Access Compliance Report

Public Rights-of-Way

(Curb Ramps)

Intersection ID: 32203	Main Street: CAMBRIDGE_GREEN_DR	Cross Street: KEW_GARDENS_LN	Location: NE
ADA ID: 117E837C4F35	Ramp Type: PerpDiag	Initial Pass/Fail: Fail	Overall Compliance: No
Severity Score: 22.5			
Codes/Mitigation Info/Possible Solution		Field Measurements/Component Compliance

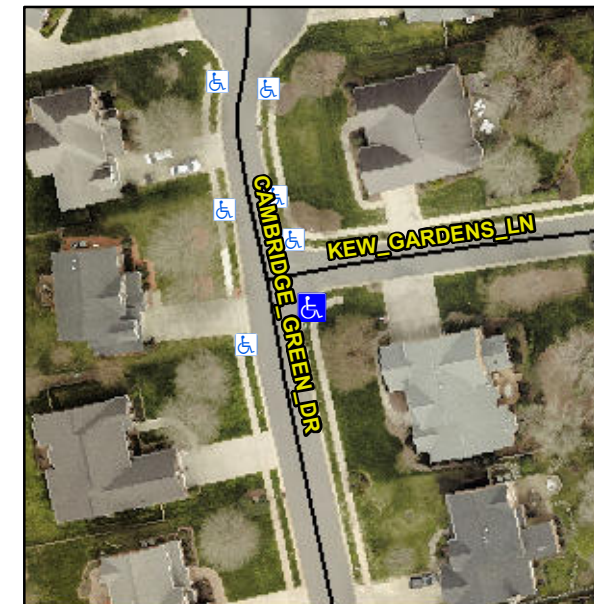
R304.5.1, R304.2.2, R304.5.3

Compliance	Description	Data	Compliance	Description	Data
N/A	Ramp Length (in)	47.0	No	Ramp Slope (%)	8.5
No	Ramp Width (in)	37.0	No	Ramp XSlope (%)	3.6
N/A	Flare Type LT	N/A	N/A	Flare Type RT	N/A
N/A	Flare Slope LT (%)	N/A	N/A	Flare Slope RT (%)	N/A
N/A	Flare Traversable LT?	N/A	N/A	Flare Traversable RT?	N/A
N/A	Landing Length (in)	N/A	N/A	DWS Provided?	N/A
N/A	Landing Width (in)	N/A	N/A	DWS Contrast?	N/A
N/A	Landing Slope (%)	N/A	N/A	DWS Length (in)	N/A
N/A	Landing X Slope (%)	N/A	N/A	DWS Full Width?	N/A
N/A	Landing Curb? (Y/N)	N/A	N/A	DWS Offset (in)	N/A
N/A	Shared Landing?	N/A			
N/A	Gutter Ponding?	N/A	N/A	Gutter Slope (%)	N/A
N/A	Gutter Lip Ht (in)	N/A	N/A	Gutter X Slope (%)	N/A
N/A	Painted X Walk1?	No	N/A	Painted X Walk2?	No
	X Walk 1 Direction	To N		X Walk 2 Direction	To W
N/A	X Walk 1 Width (in)	N/A	N/A	X Walk 2 Width (in)	N/A
	X Walk 1 Slope (%)	0.7		X Walk 2 Slope (%)	3.1
	X Walk 1 X Slope (%)	1.2		X Walk 2 X Slope (%)	2.8

Remove & Replace Curb Ramp With Two New Directional Ramps or Equivalent.
